NUMBER 48

BULLETIN

SUBJECT: MUFFLERS: 1. Failure of Inner-Baffle End Attachments
2. Inspection
3. Remedial Measures for Preventing Engine Failure

MODELS AFFECTED: J4A and J4F, Serial Nos. 4-828 to 4-1384 inclusive
(EXCLUDING 4-1372)

MUFFLER BAFFLE SUPPORT

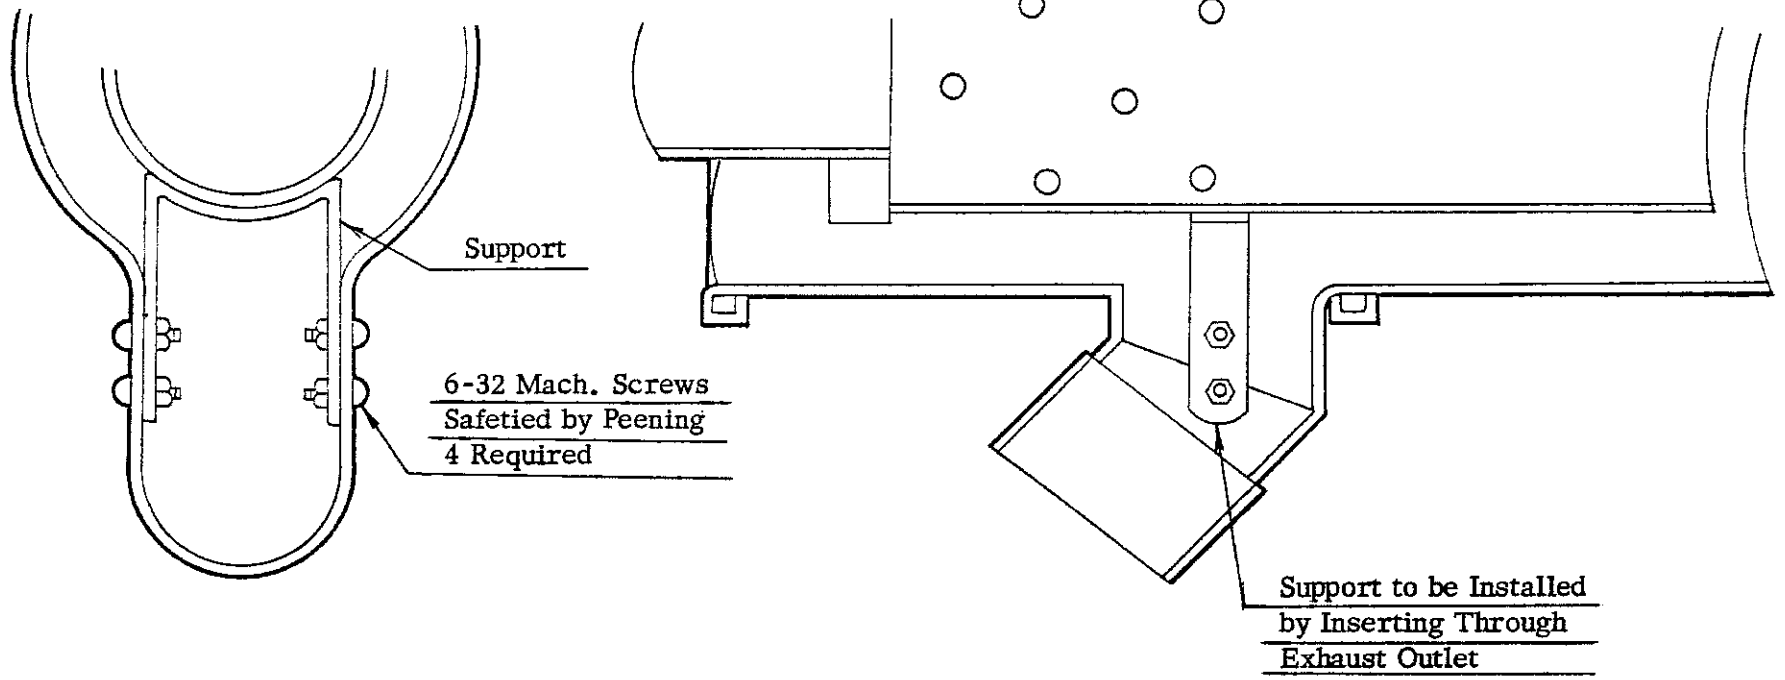
The failures consist of the end attachments of the inner perforated baffle breaking loose thereby permitting the baffle to fall down covering the muffler exhaust outlet.

This type of failure will cause excessive back pressure in the exhaust system with resulting interruption of engine operation.

Upon receipt of this bulletin it will be necessary to inspect your muffler assembly to ascertain if the inner baffle is loose. This may best be accomplished by removing the muffler shroud and tailpipe and tapping the muffler inner baffle gently with a stick or rod by inserting it through the muffler exhaust outlet.

However, if the muffler is found to be satisfactory, the enclosed support clip must be installed immediately per the instructions on the attached sketch in order to prevent the inner baffle from covering the exhaust outlet if the end attachments should fail sometime in the future.

Inner Baffle to be Inspected
Through Exhaust Outlet for
Loose End Connections

If upon inspection the inner baffle is found to be loose, the muffler assembly should be replaced by an improved type muffler, Part No. A7236. Mufflers for replacement may be obtained at manufacturing costs by contacting your local dealer or distributor.
